Attachment 1a

Improved Technical Specifications for McGuire Units 1 and 2
Marked Copy

Attachment 1b

Improved Technical Specifications for Catawba Units 1 and 2
Marked Copy

Figure 2.1.1-1

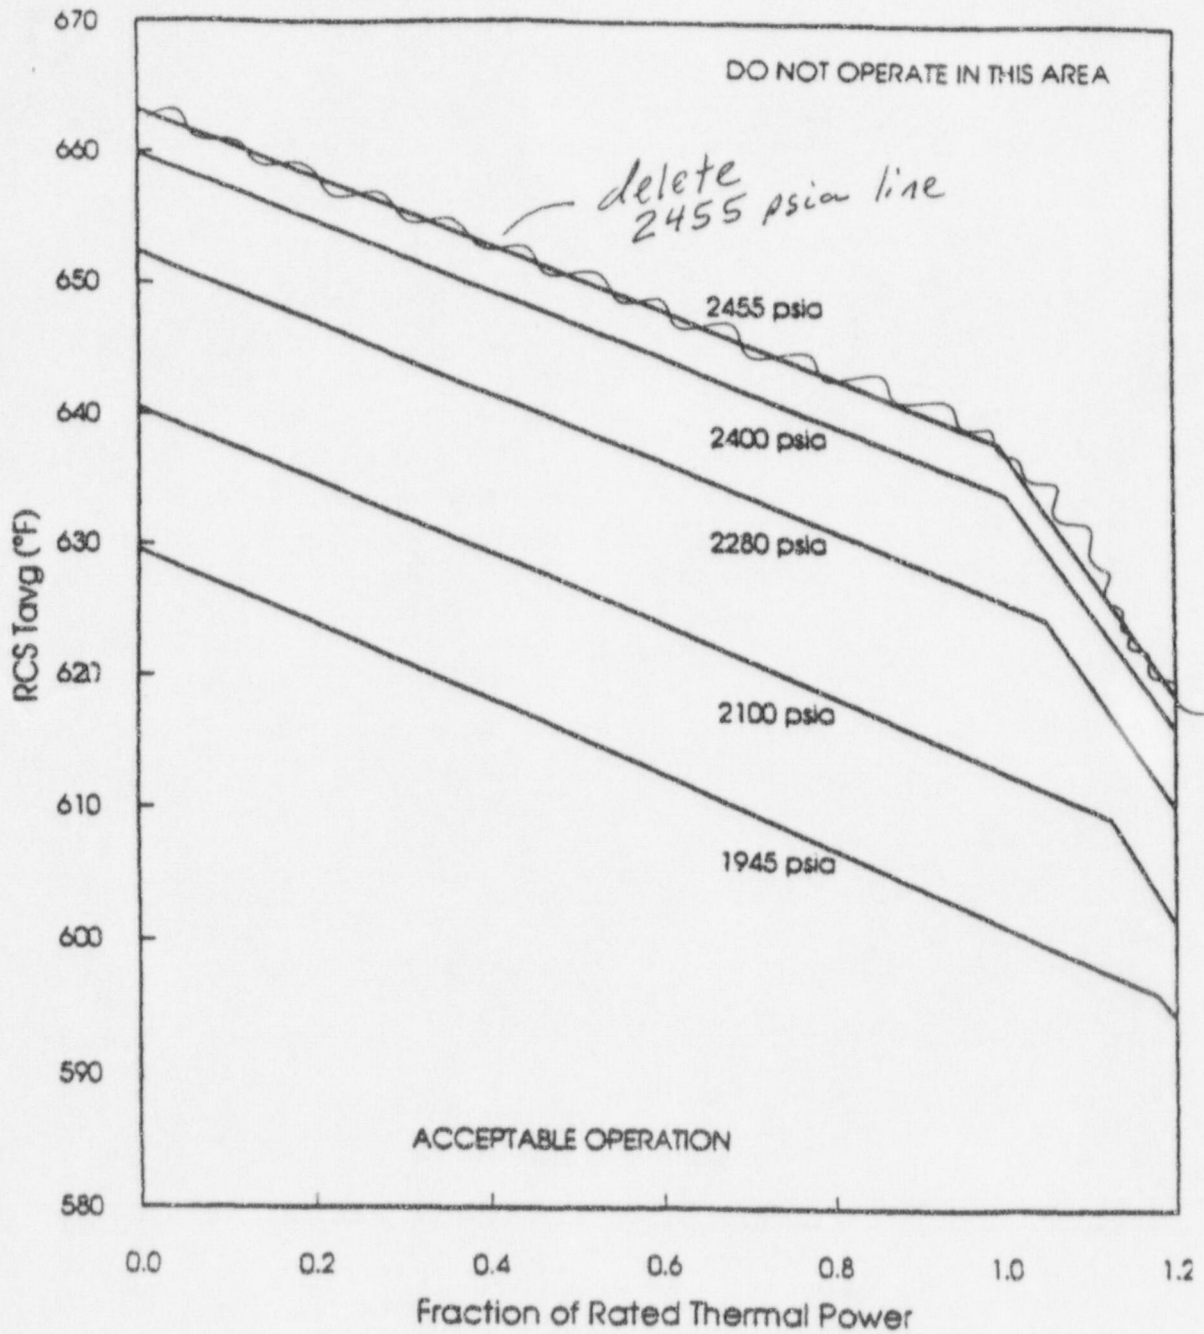
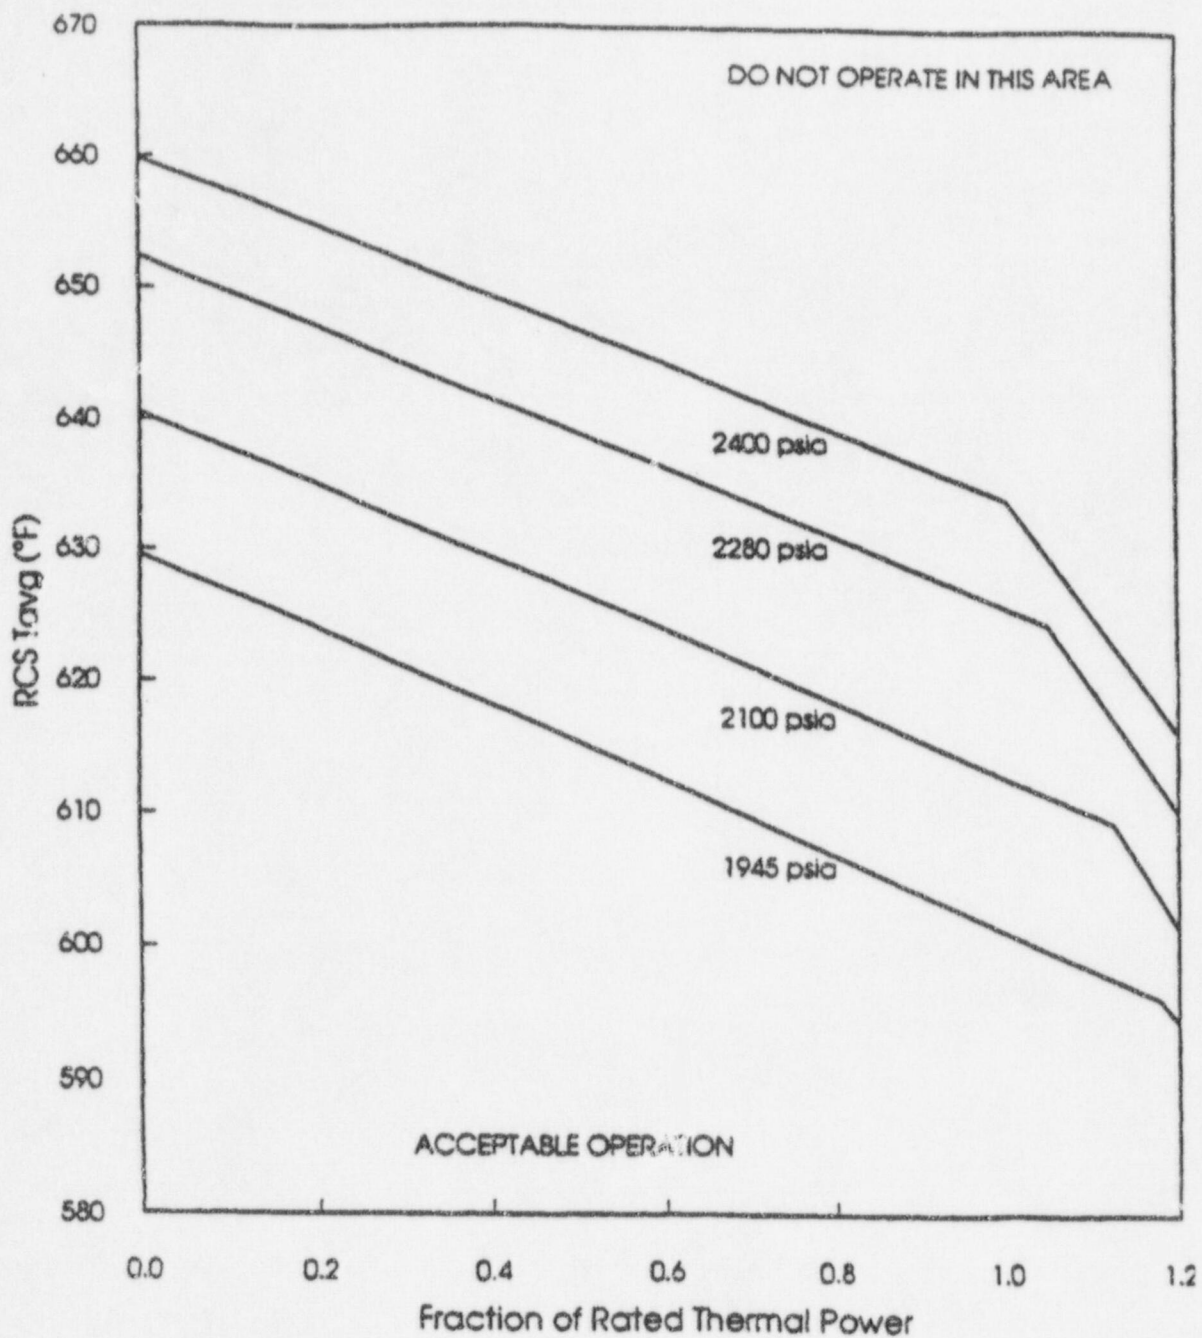
Reactor Core Safety Limits -
Four Loops in Operation

Figure 2.1.1-1

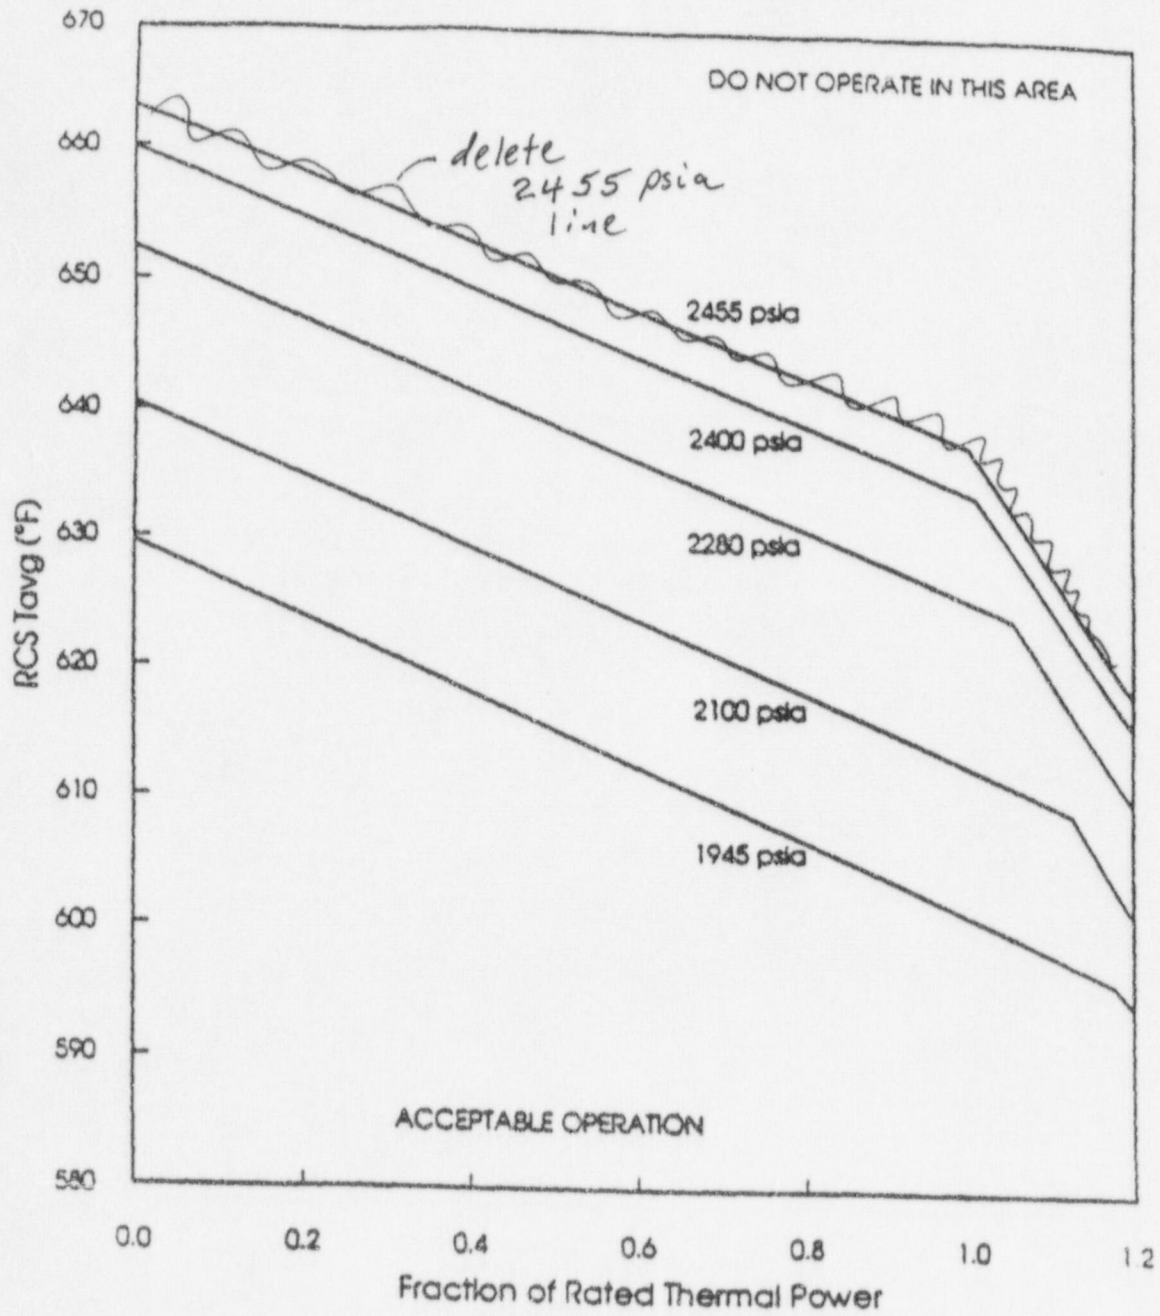
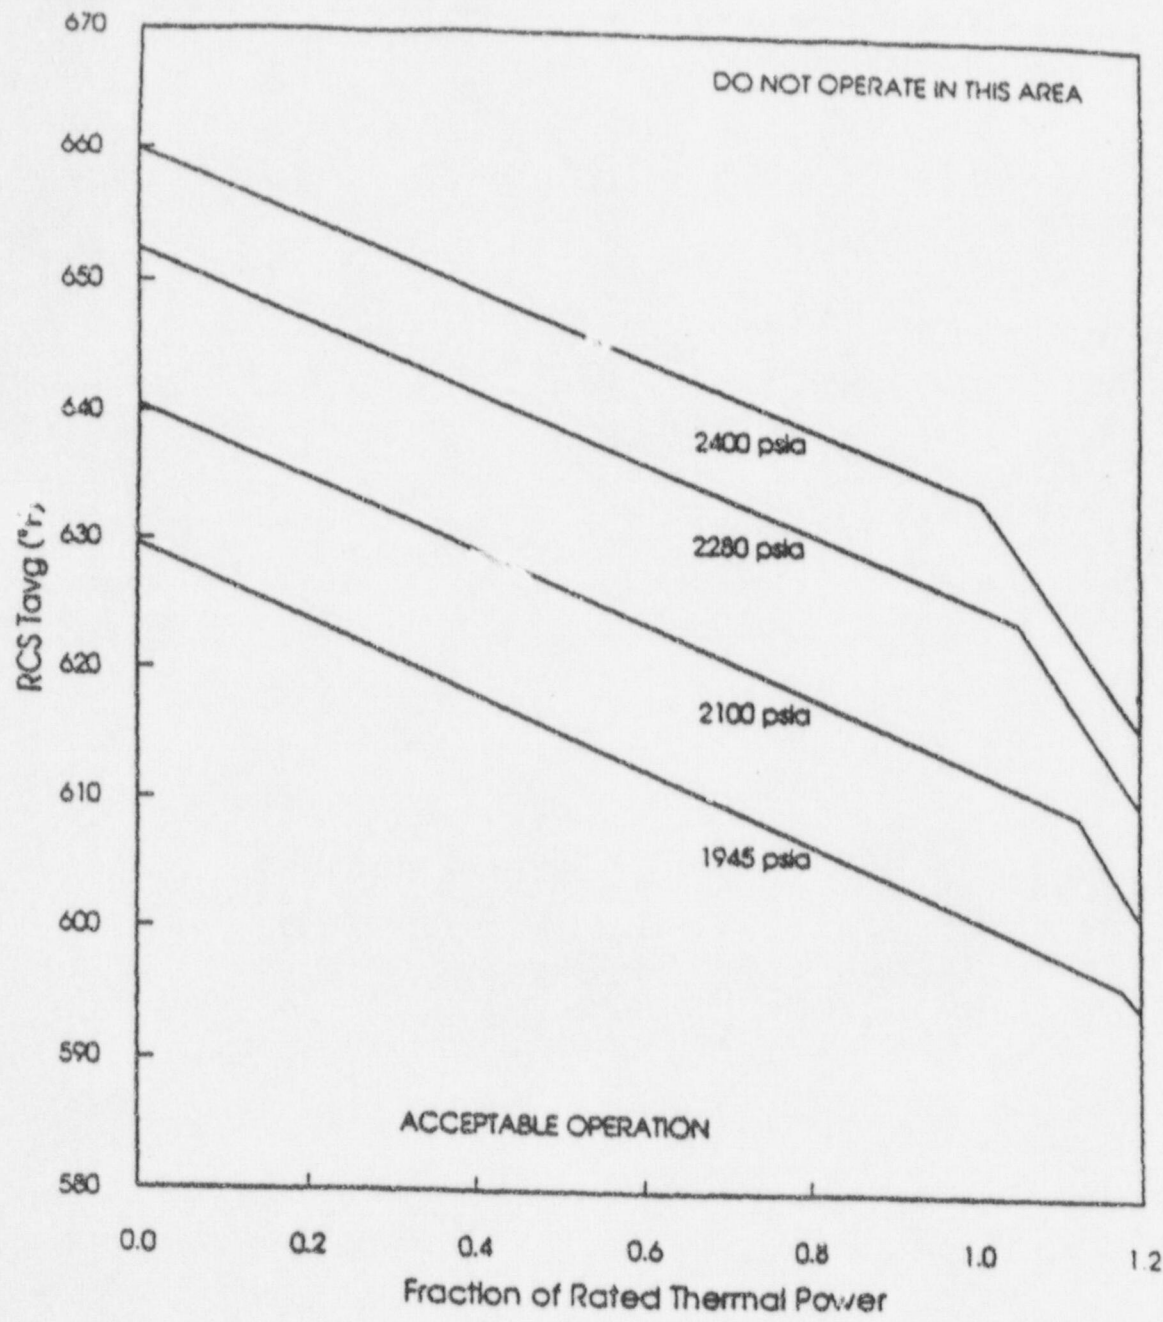
(UNIT 1 ONLY)

Reactor Core Safety Limits -
Four Loops in Operation

Figure 2.1.1-1

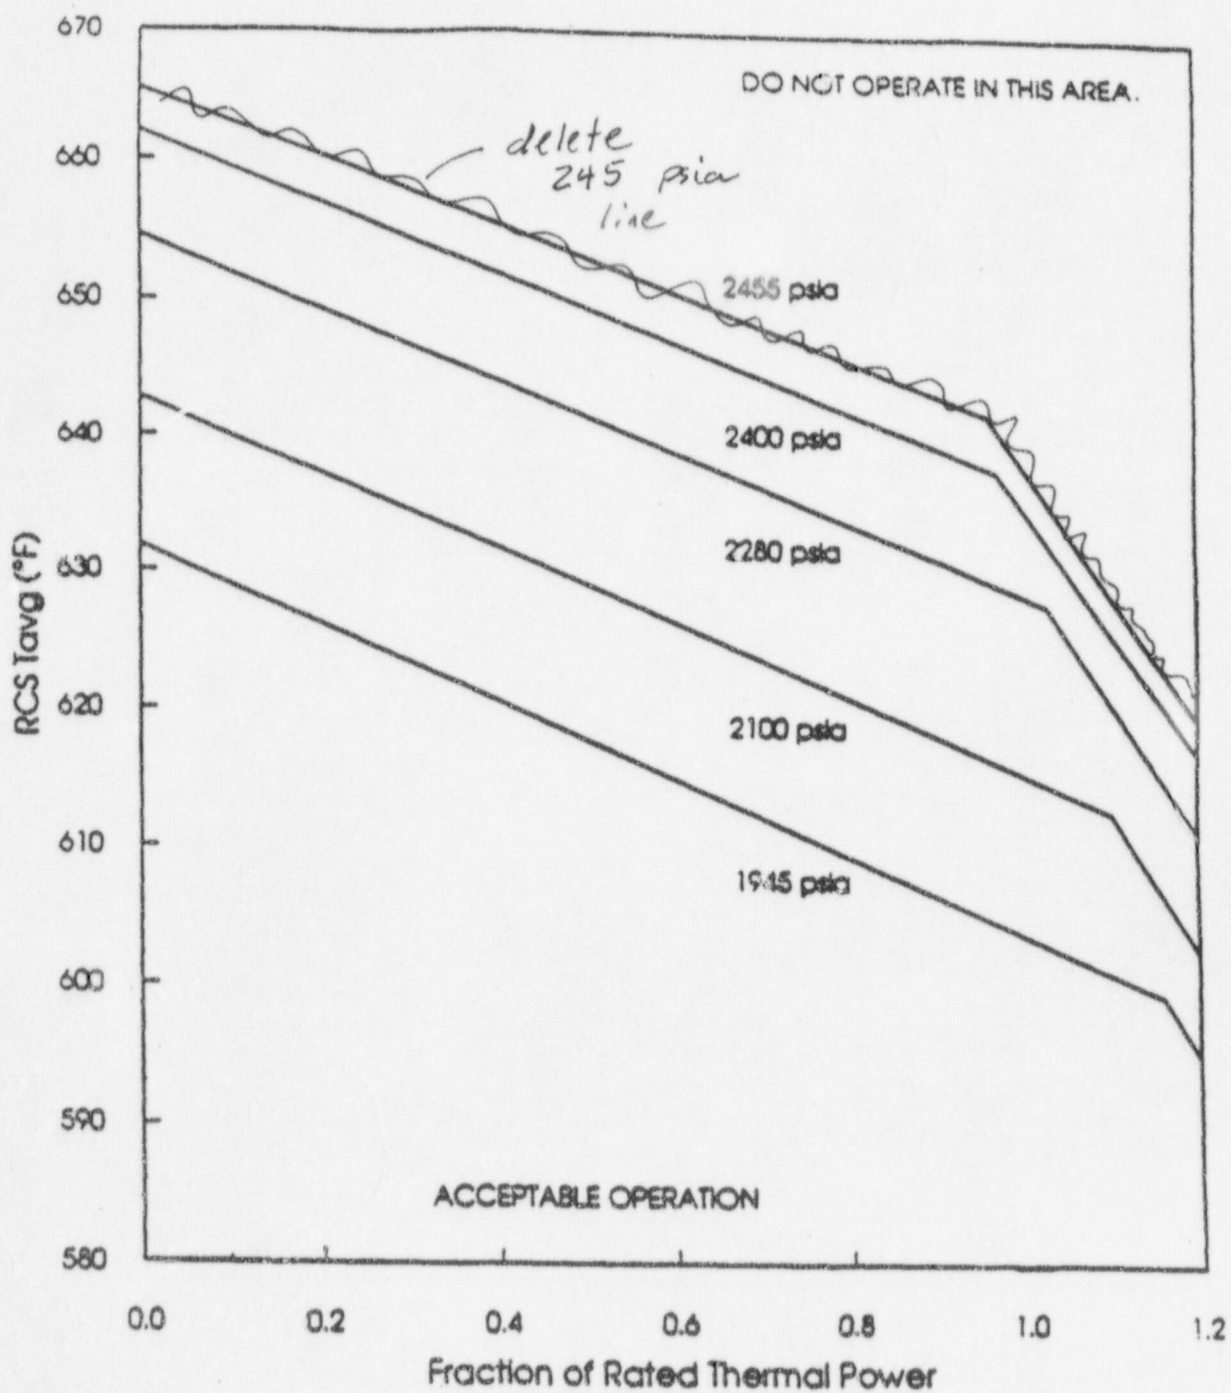
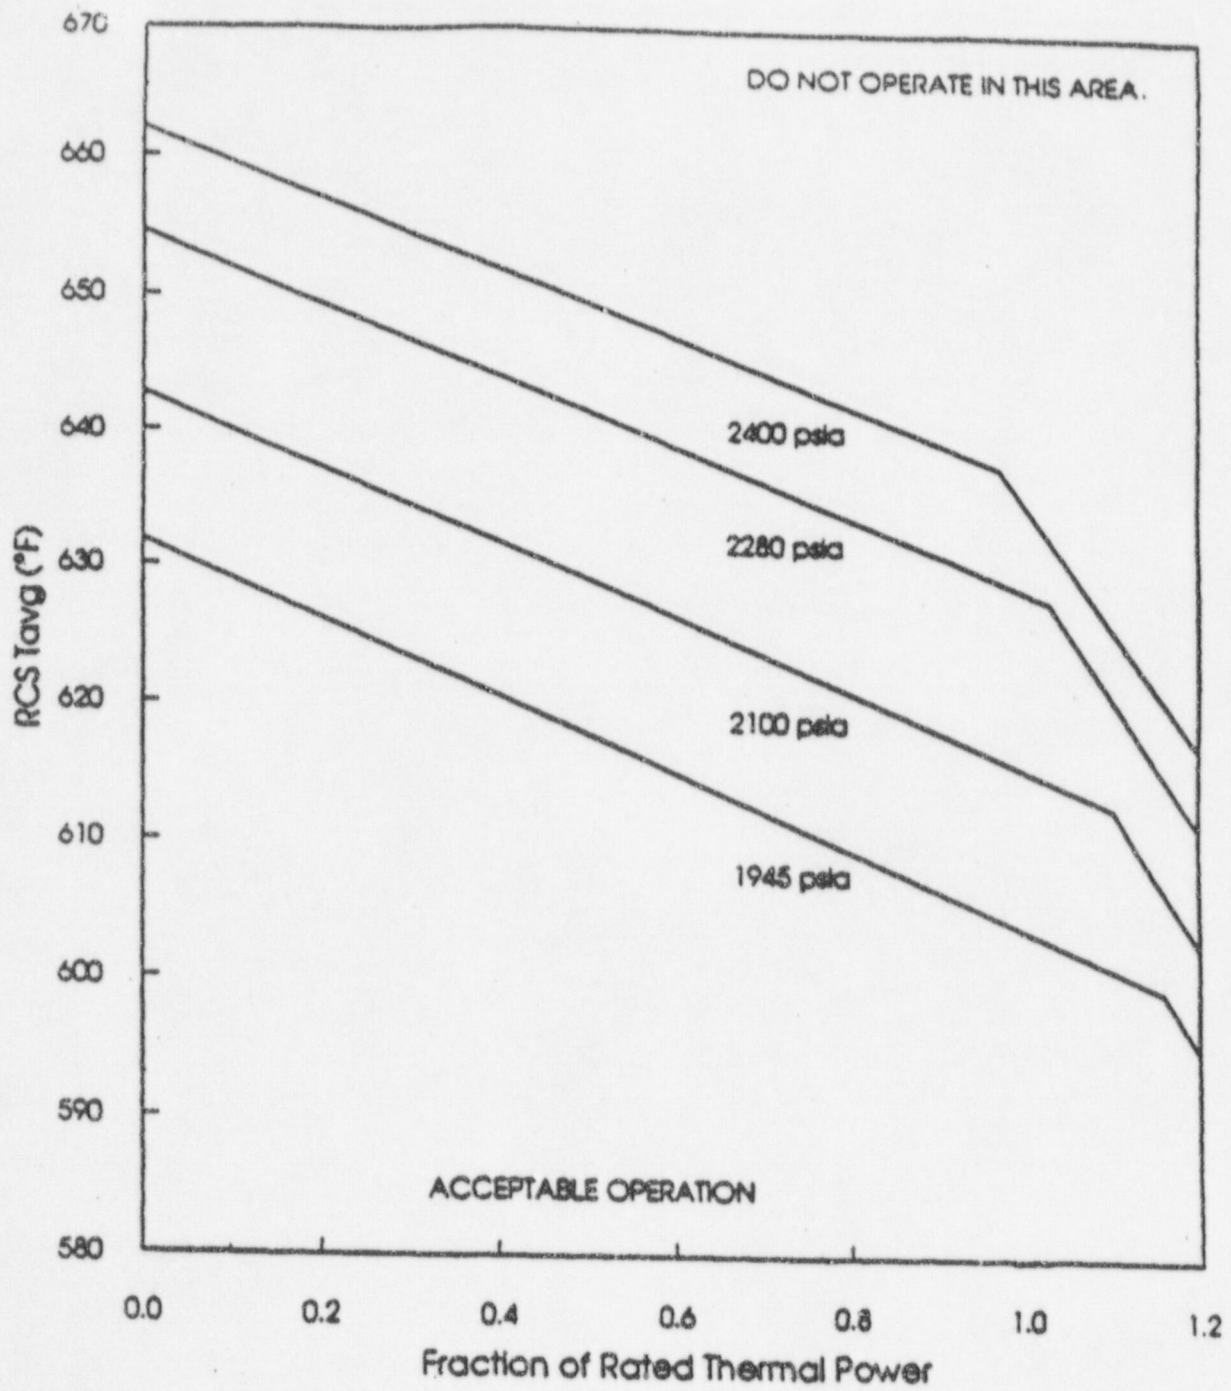
(UNIT 2 ONLY)

Reactor Core Safety Limits -
Four Loops in Operation
